Planning Commission Staff Report

Project type: Amended Architectural Elevations

Location: 101 Hilltown Village Center

Description: **Hilltown Village Center (AAE):** Amended Architectural Elevations and Architect's Statement of Design for a 13.0 acre tract of land zoned "C-8" Planned Commercial District located at the northeast corner of the intersection of Olive Boulevard and Chesterfield Parkway (18S521108 & 18S630327).

Proposed Building C

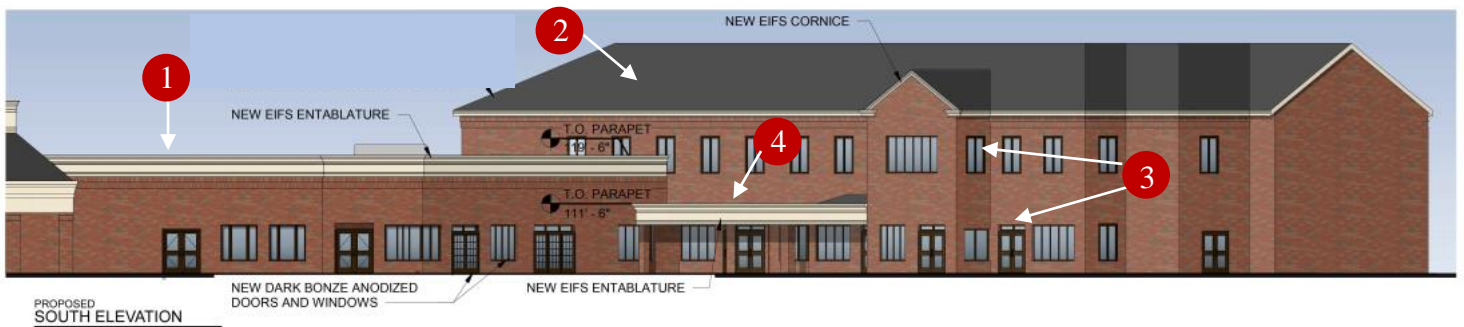
As with building A, the applicant is proposing to change three different elements of the design as follows:

- 1 Add a light colored EIFS entablature.
- 2 Change the rooftop shingles to a dark charcoal color.
- 3 Add new dark bronze anodized doors and painted window frames.

Additionally, the EIFS for building C would add screening of the rooftop equipment to the front facade. It should be noted, however, that as shown in images below, the rooftop equipment can be seen from the rear of the building, including from Hilltown Village Ctr.

- Paint the rooftop mechanical units of building D to match the EIFS color; and
- Provide additional evergreen trees to fill in exposed gaps to the rear area of building C as this provides a significant amount of screening.
